# UNITED STATES PATENT AND TRADEMARK OFFICE

APPLICATION NO.	FILING DATE	FIRST NAMED INVENTOR	ATTORNEY DOCKET NO.	CONFIRMATION NO.
10/789,870	02/26/2004	Tadashi Maegawa	P/1250-272	3619
2352 7590 09/05/2007 OSTROLENK FABER GERB & SOFFEN 1180 AVENUE OF THE AMERICAS NEW YORK, NY 100368403			EXAMINER MACARTHUR, SYLVIA	
			ART UNIT 1763	PAPER NUMBER
			MAIL DATE 09/05/2007	DELIVERY MODE PAPER

<b>Office Action Summary</b>	<b>Application No.</b> 10/789,870	<b>Applicant(s)</b> MAEGAWA ET AL.	
	<b>Examiner</b> Sylvia R. MacArthur	<b>Art Unit</b> 1763

## **DETAILED ACTION**

Fig. 2

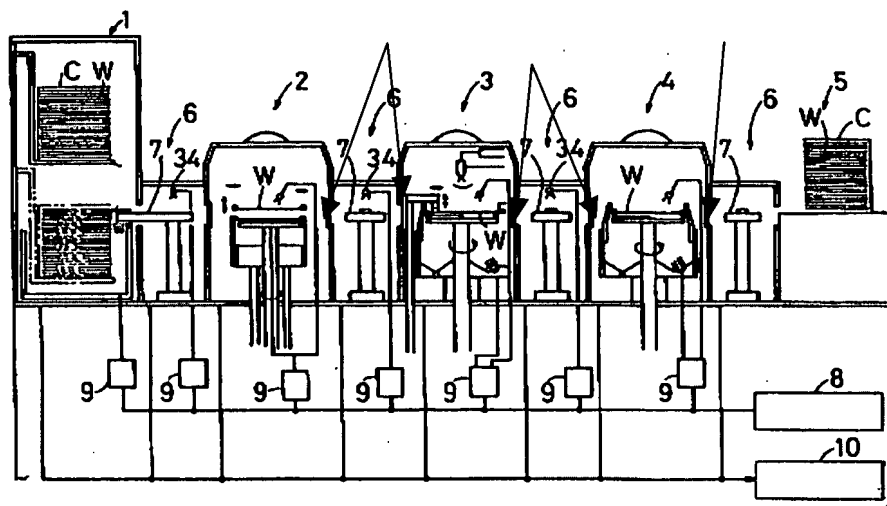
The examiner has inserted a copy of Figure 2 of Shinbara to mark her interpretation of a shutter or door to isolate the atmospheres between the chambers.

a liquid chemical processing chamber including said liquid chemical processing part; and a transport chamber 20 provided with said third opening, said transport chamber allowing transportation of substrates by said second transport mechanism, and wherein atmospheres in said liquid chemical processing chamber and said transport chamber can be isolated from each other via the partition plate shown in Fig. 2.
